Proposed Plan View

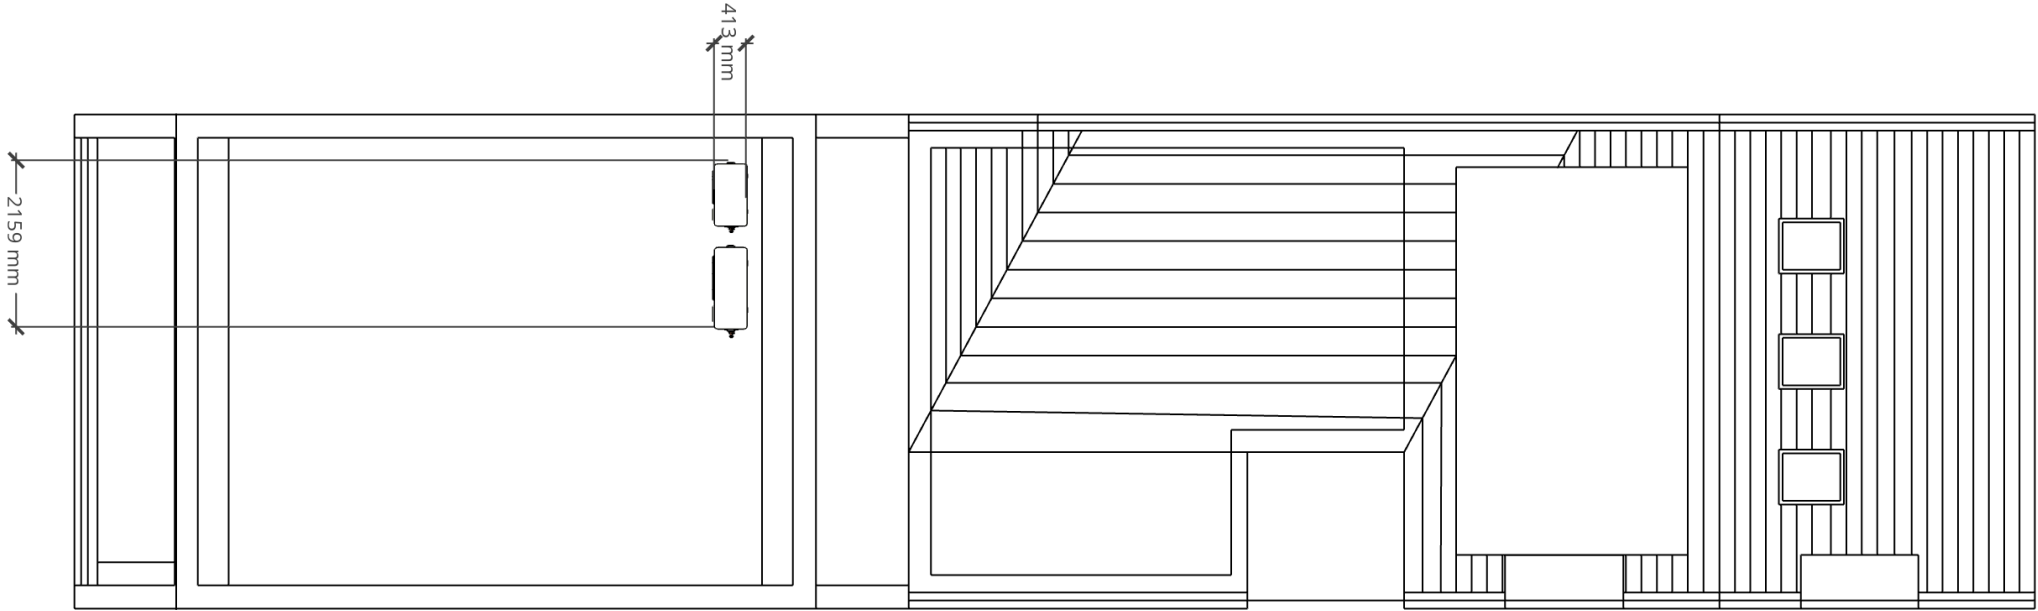
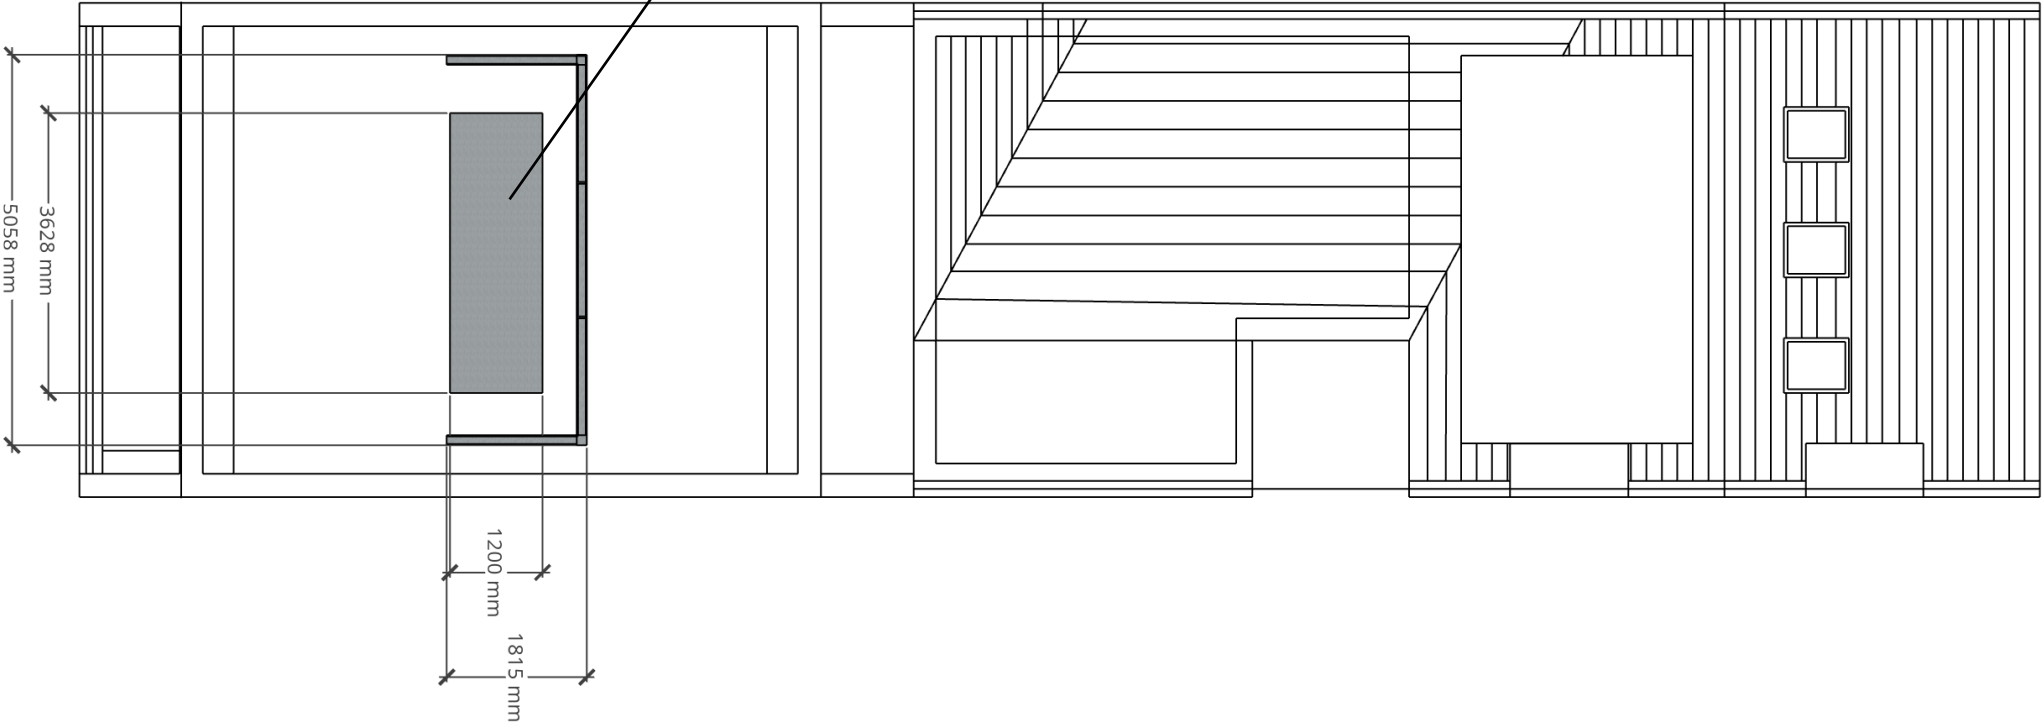
- Proposed Enclosure and Acoustic Screen
- Units are to be moved further away from the closest windows.
